TOWN OF MILFORD, NH
OFFICE OF COMMUNITY DEVELOPMENT

Date: October 11, 2022
To: Planning Board
From: Camille Pattison, NRPC Assistant Director
Subject: SP2022-08 Sooner Transportation LLC, for the property located at Tax Map 12, Lot 11, 754-756 Elm Street (Horseless Carriage Site). Public Hearing for a Major Site Plan Application to construct a two-story, 10,320 sf. auto sales and repair facility with associated parking, stormwater management/drainage, landscaping, and lighting improvements on the subject property located in the Commercial ‘C’ Zoning District and West Elm Overlay District.

**Re: Sooner Milford Site Plan (Tax Map 12, Lot 11) – 754 and 756 Elm Street
Site Plan Drainage Review**

SOONER MILFORD SITE PLAN

TAX MAP 12 LOT 11
OVERVIEW & SITE PLAN
SOONER-MILFORD
 LOCATED AT:
754-756 ELM STREET
MILFORD, NEW HAMPSHIRE, 03055
 OWNER: LAND BARGE, LLC
 754-756 ELM STREET
 MILFORD, NH 03055
 APPLICANT: SOONER TRANSPORTATION LLC
 3 EXECUTIVE PARK DRIVE, SUITE 201G
 BEDFORD, NH 03110

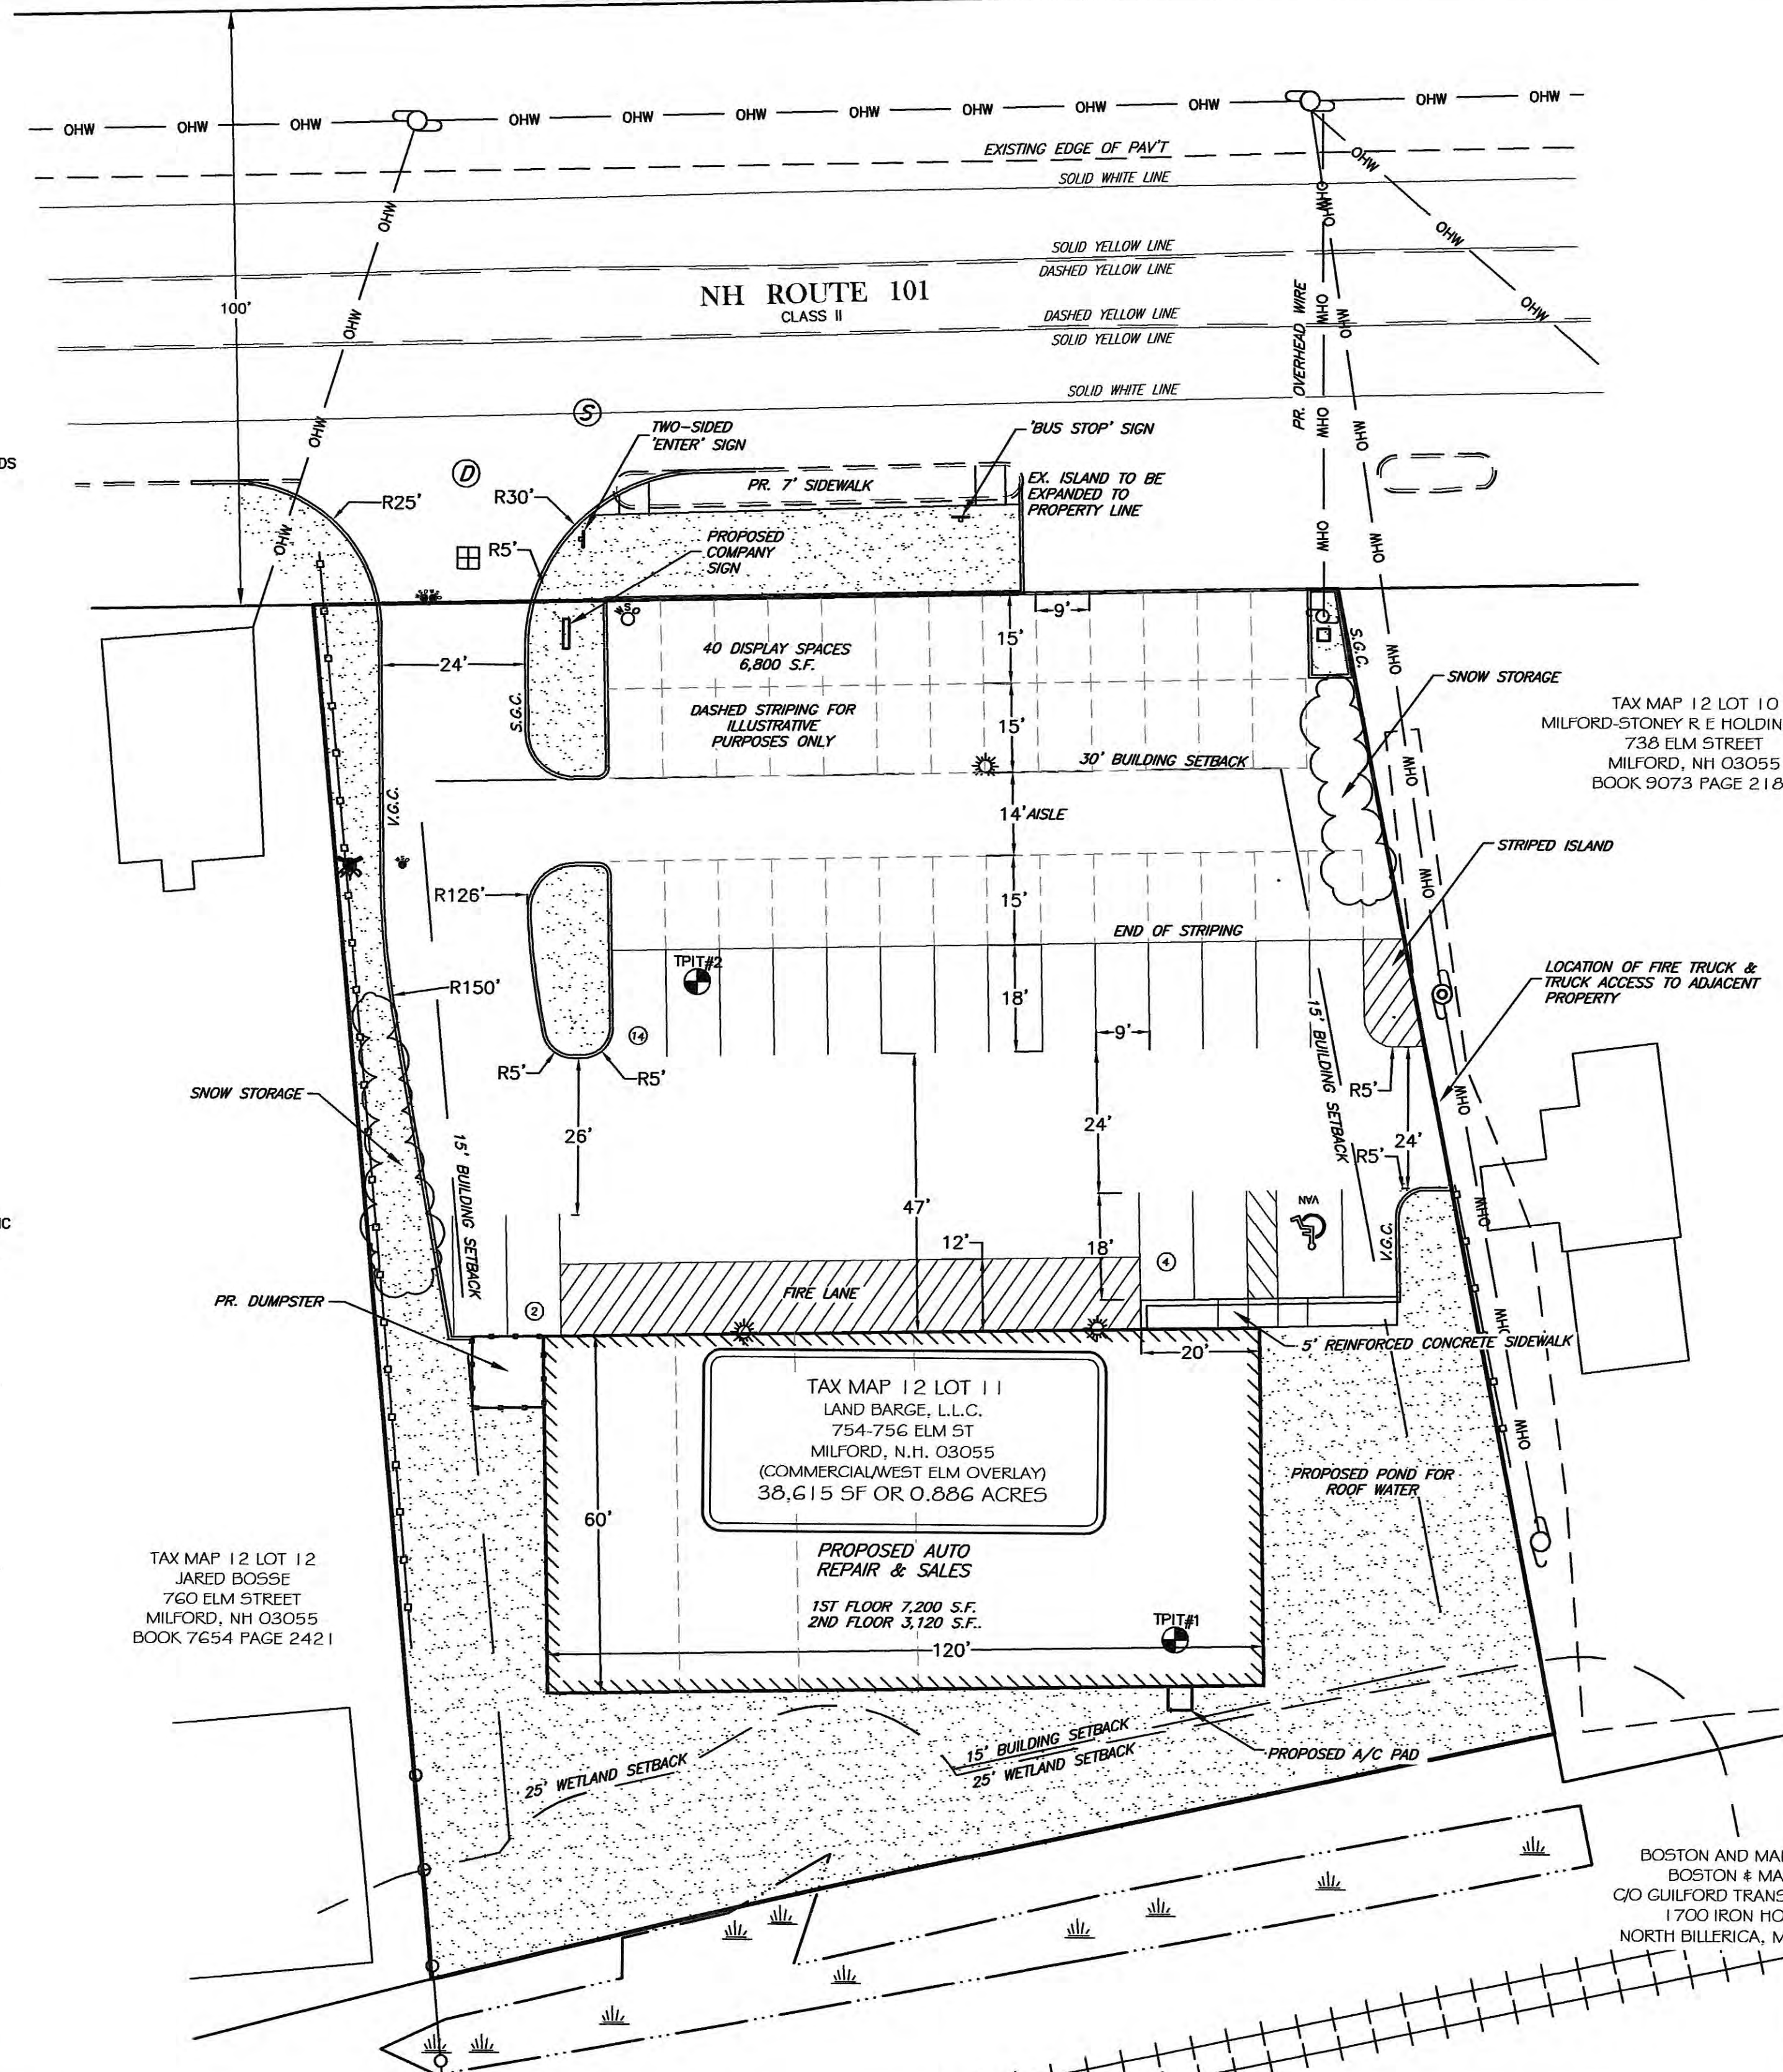
8. Sheet 1, Note 8 – Please update the site plan to include the existing and resulting open space calculations in the *Dimensional Regulations: Commercial* table. *Resolved*

11. Sheet 1 – The plan displays a 12' wide loading area within the state owned right of way. The proposal may effect and impact the traffic conditions on Elm Street and abutting properties. Further as stated in Section 6.05.6.E, all off-street parking and loading or unloading spaces shall be at least ten feet (10') from any public street right-of-way and shall be separated from such right-of-way by a granite curb and landscaping as required in 6.08 LANDSCAPING STANDARDS. The proposal require a waiver of these requirements and require NHDOT approval and dedicated easement to use the area within the right of way.

12. Sheet 1 – The plan shows display parking space partially located off the property and within the State right-of-way. As stated in the Zoning Ordinance, Section 6.05.6.E, Parking and loading spaces shall be arranged so that cars will not back into public roads. The plan will need to amended to relocate said parking spaces within the subject property at least 10 feet from the Elm Street public right-of-way.

13. Sheet 1 - The applicant should explain the internal circulation, access/egress patterns for the 40 display vehicles. At a minimum, the plan should be revised to include the appropriate isle widths between the rows of display vehicle parking. *One row of cars has been removed and a 14' aisle added.*

14. Sheet 1 – Staff questions if the adequate snow storage areas have been provided. A note should be added to the plan stating that snow shall be removed to an offsite location using best management practices. *Resolved see not 16 on Sheet 1.*

8. Sheet 1, Note 8 – Please update the site plan to include the existing and resulting open space calculations in the *Dimensional Regulations: Commercial* table.

11. Sheet 1 – The plan displays a 12' wide loading area within the state owned right of way. The proposal may effect and impact the traffic conditions on Elm Street and abutting properties. Further as stated in Section 6.05.6.E, all off-street parking and loading or unloading spaces shall be at least ten feet (10') from any public street right-of-way and shall be separated from such right-of-way by a granite curb and landscaping as required in 6.08 LANDSCAPING STANDARDS. The proposal require a waiver of these requirements and require NHDOT approval and dedicated easement to use the area within the right of way.

12. Sheet 1 – The plan shows display parking space partially located off the property and within the State right-of way. As stated in the Zoning Ordinance, Section 6.05.6.E, Parking and loading spaces shall be arranged so that cars will not back into public roads. The plan will need to be amended to relocate said parking spaces within the subject property at least 10 feet from the Elm Street public right-of-way.

13. Sheet 1 - The applicant should explain the internal circulation, access/egress patterns for the 46+ display vehicles. At a minimum, the plan should be revised to include the appropriate aisle widths between the rows of display vehicle parking.

14. Sheet 1 – Staff questions if the adequate snow storage areas have been provided. A note should be added to the plan stating that snow shall be removed to an offsite location using best management practices.

TAX MAP 12 LOT 11
LIGHTING, & LANDSCAPE PLAN
SOONER-MILFORD
 LOCATED AT:
754-756 ELM STREET
MILFORD, NEW HAMPSHIRE, 03055
 OWNER: LAND BARGE, LLC
 754-756 ELM STREET
 MILFORD, NH 03055
 APPLICANT: SOONER TRANSPORTATION LLC
 3 EXECUTIVE PARK DRIVE, SUITE 2016
 BEDFORD, NH 03110

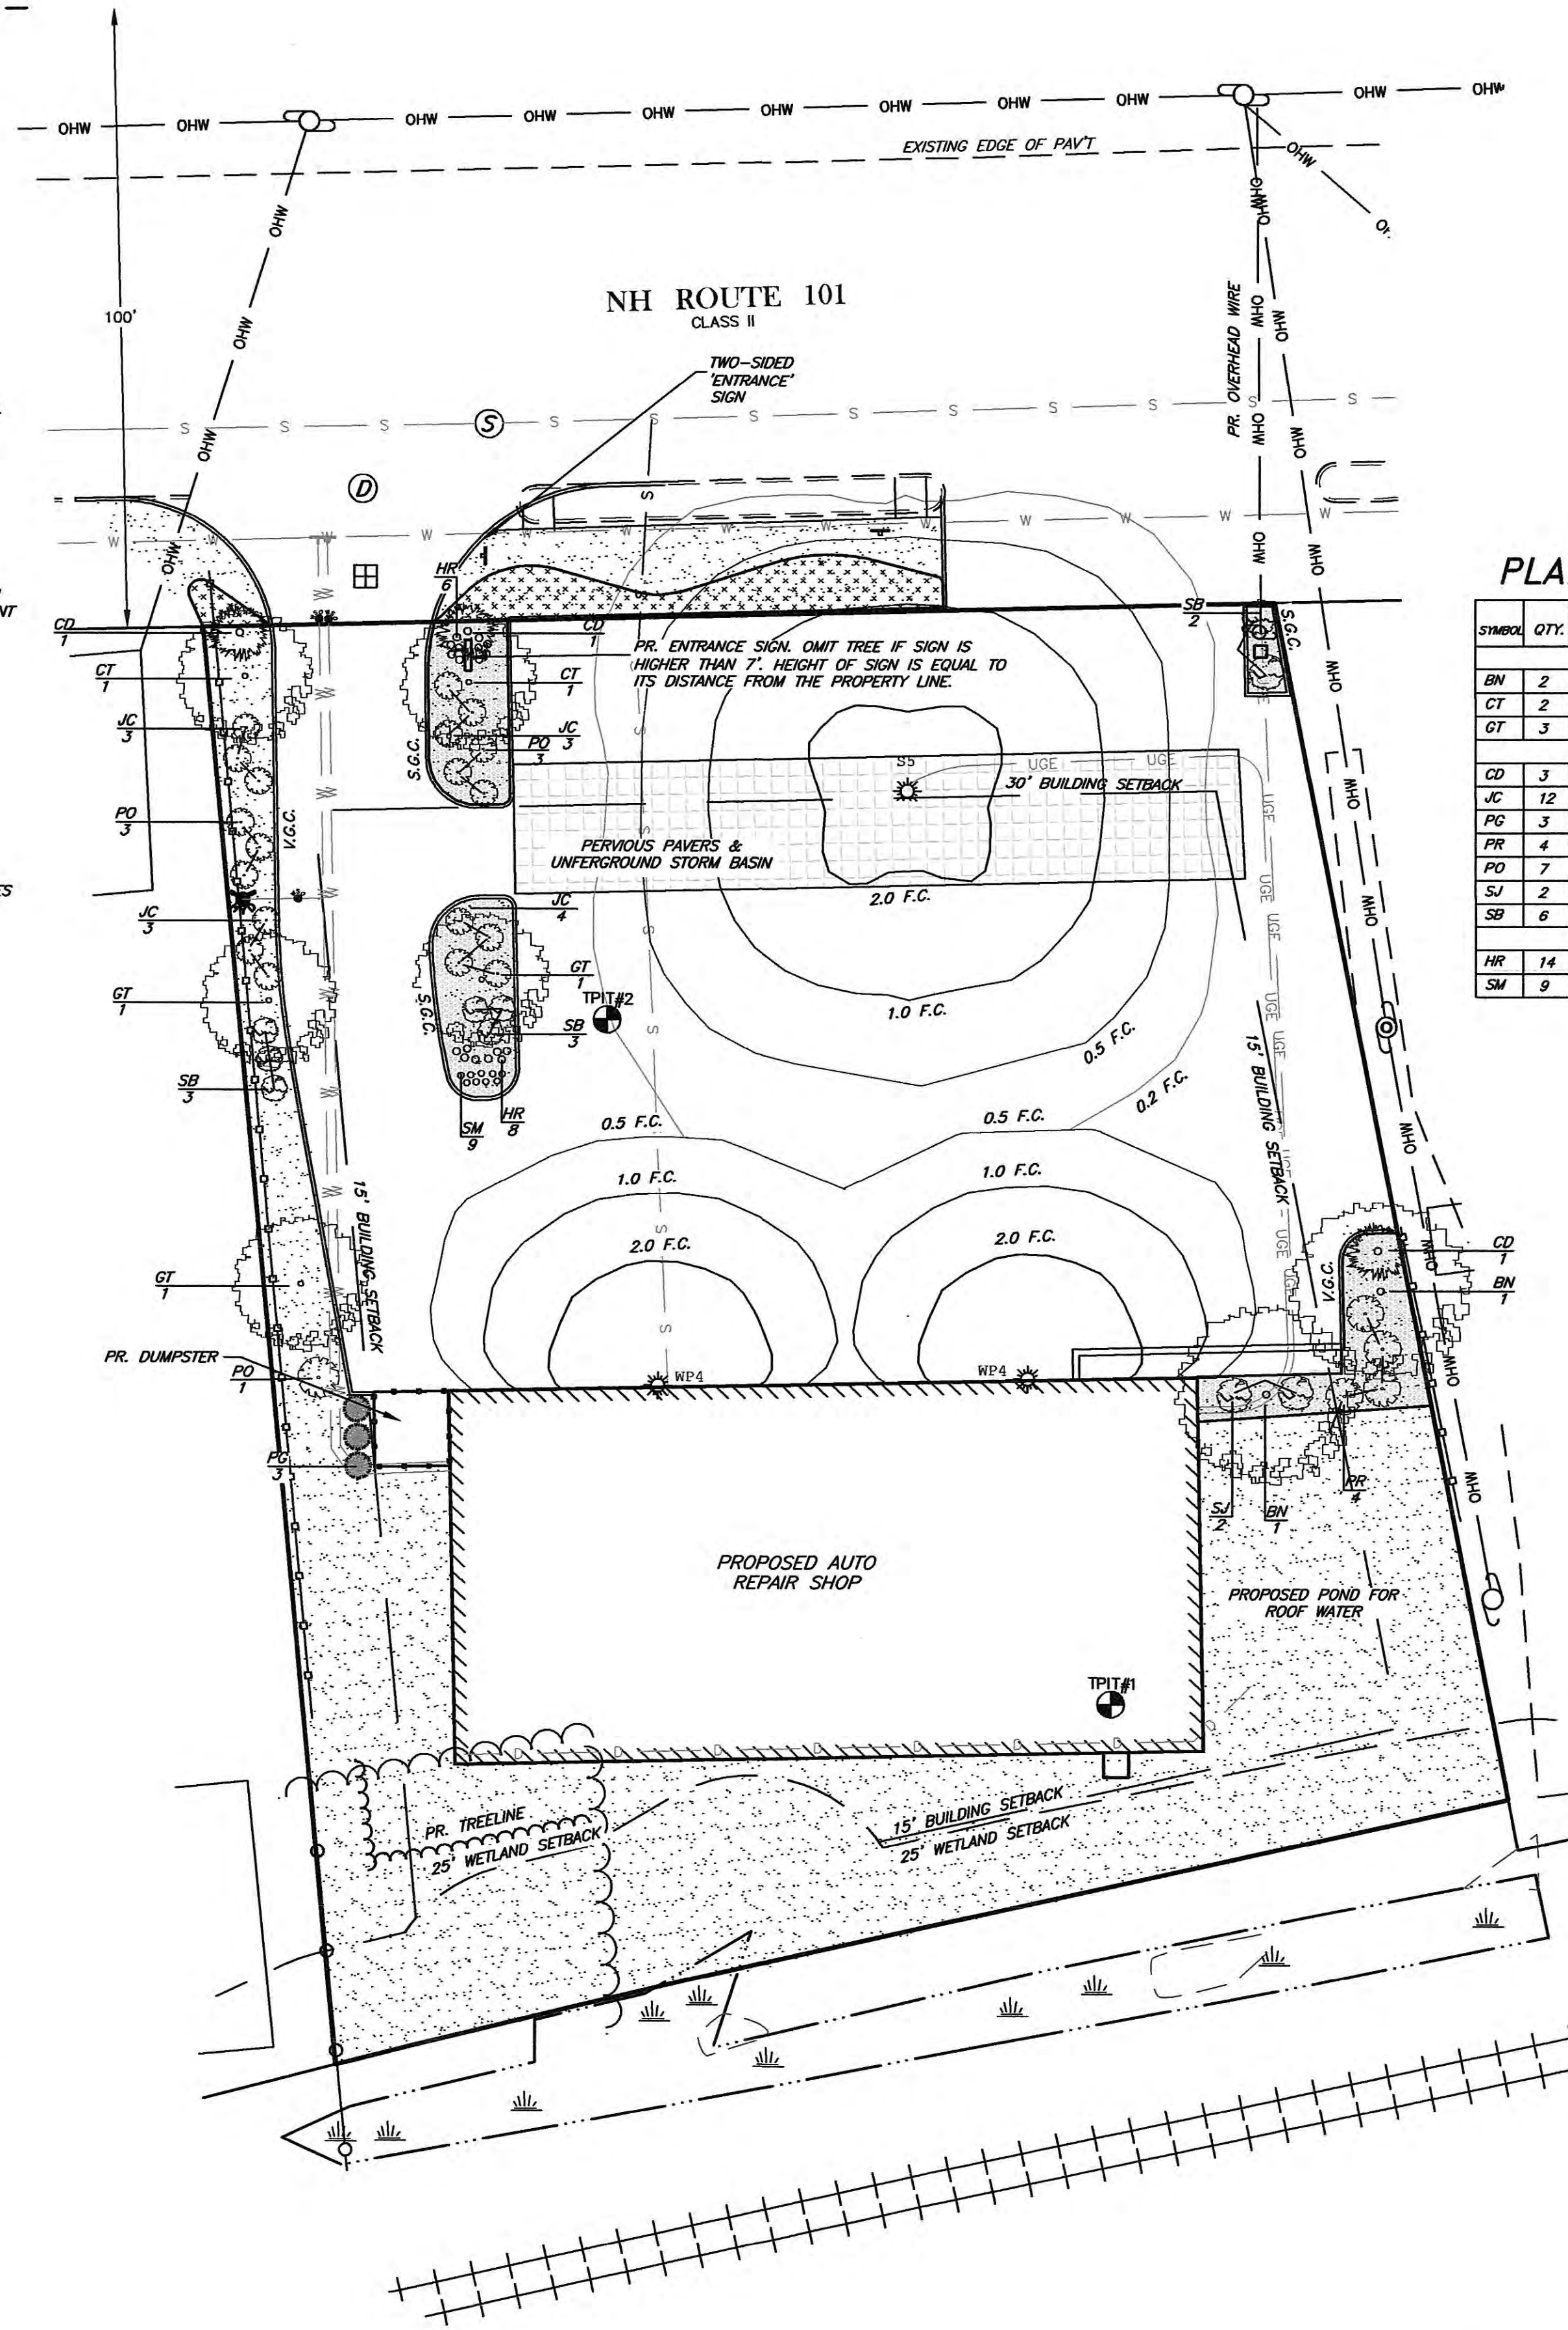
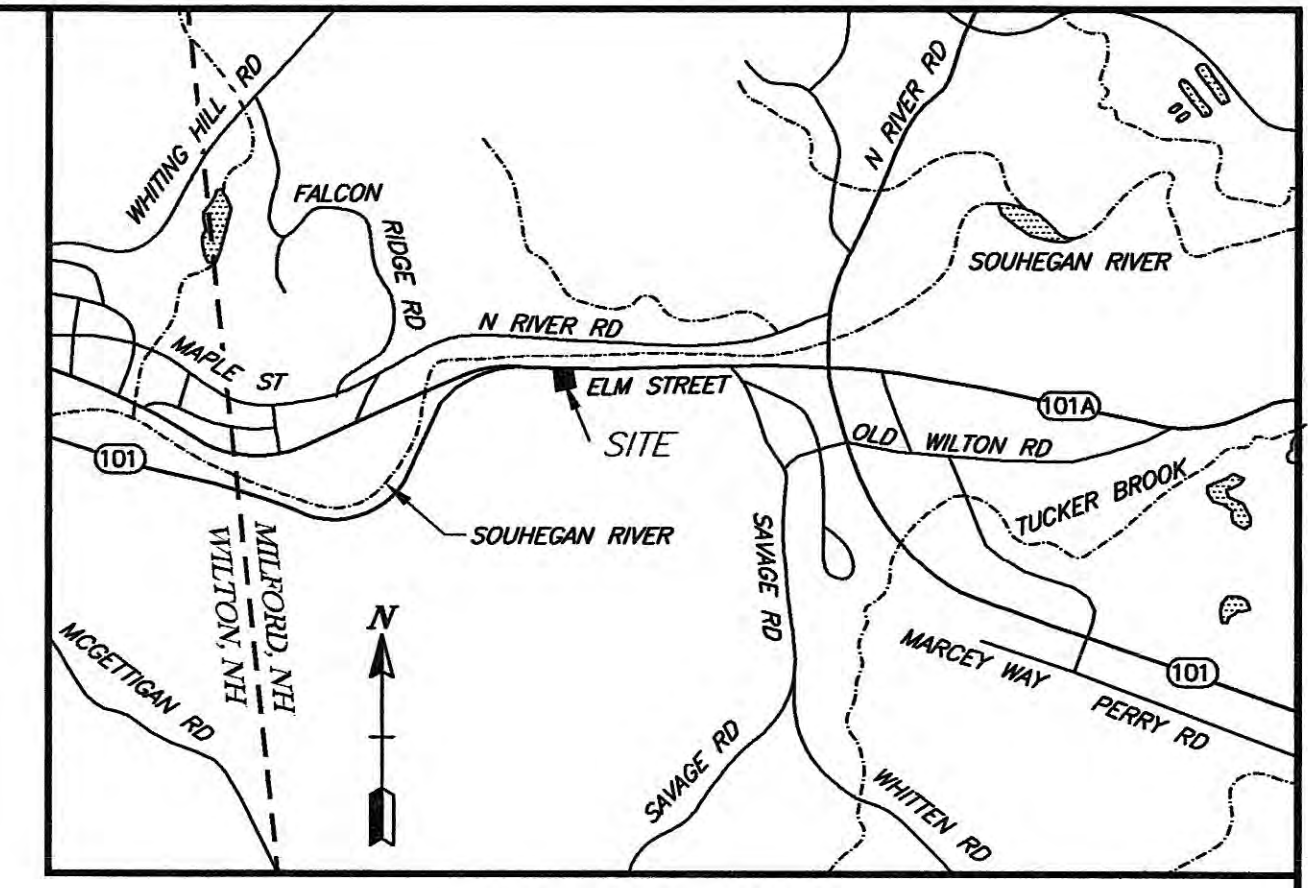
16. Sheets 1 and 6 - Pursuant to the Zoning Ordinance, Section 6.07.6.E.2.b, the proposed building should enhance the definition of each floor of the building through terracing, material changes, articulated structural elements, changes in materials and horizontal trim bands. The applicant should explain how the proposed building complies with this section. *Waiting on architectural plans.*

17. Sheets 1 and 6 – Please explain how the proposed building architectural features and materials comply with the Zoning Ordinance, Section 6.07.6.E.3. *Waiting on architectural plans.*

18. Sheets 1 and 6 – Pursuant to the Zoning Ordinance, Section 6.07.6.E.4.a, the proposed building design should avoid blank walls at ground-floor levels through the use of windows, trellises, material changes, arcades, or other features to increase visual interest. The applicant should be prepared to discuss how the proposed building complies with the section. *Waiting on architectural plans.*
